SERVICE BULLETIN

Number: 09-002

EC Series Electrical System Mandatory Product Improvement

Fig 1

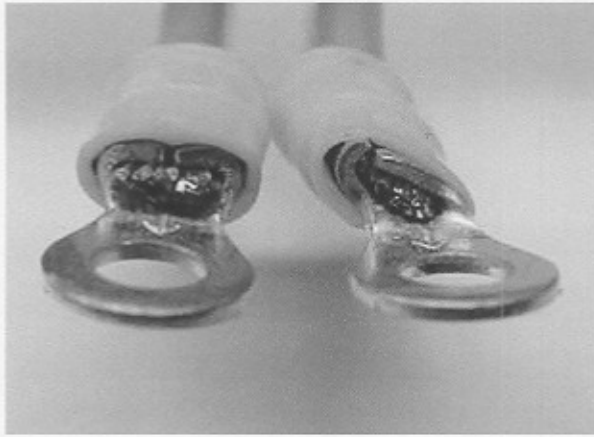
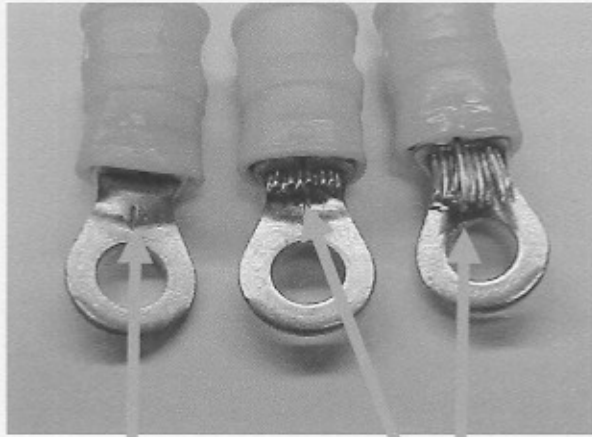
1. Crimps on the wires going to the terminal strip of the relay board should be uniform and tight. There should be no bare wire visible between the wire insulation and the terminal, and strands flush with terminal barrel. (Fig 1 & Fig 2)

Correct Position

Poor Position In Crimper

Correct

Poor Wire strands Too long
